**REMARKS**

The last Office Action of May 8, 2002 has been carefully considered.

**IN THE DRAWING:**

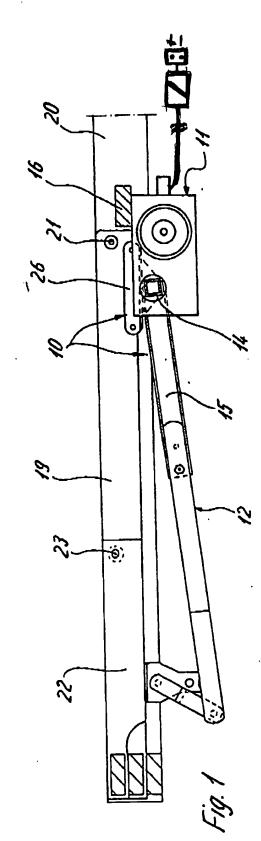
It is noted that the drawings are objected to because of applicant's failure

to show every feature set forth in the claims. It is further noted that claim 13 is

Applicant submits herewith new Figure 1 to show the feature of claim 13.

Applicant has made amendments to the FIG. 1 in order to obviate the

[0039]--The stationary stop member 25 is so operatively connected to the rotary drive mechanism 11 that the dc motor is cut as soon as the lifting arm 25 strikes against the stop member 25. In order to prevent a risk of damage, it is suitable to incorporate an overload relay [(not shown)] as schematically shown in FIG. 1 in the power supply line (not shown) of the rotary drive mechanism. The overload relay opens the motor circuit when the current in the circuit is excessive and exceeds a preset value, thereby providing an overload protection. The provision of a stop member for restricting a movement of the back portion 19 is simple and cost-efficient. Of course, the use of limit switches is also conceivable. Also, the stop member 25 may be resilient so that the increase of current becomes smoother, thereby further protecting the rotary drive mechanism 11.--

Amend FIG. 1 as per copy enclosed and indicated in red.
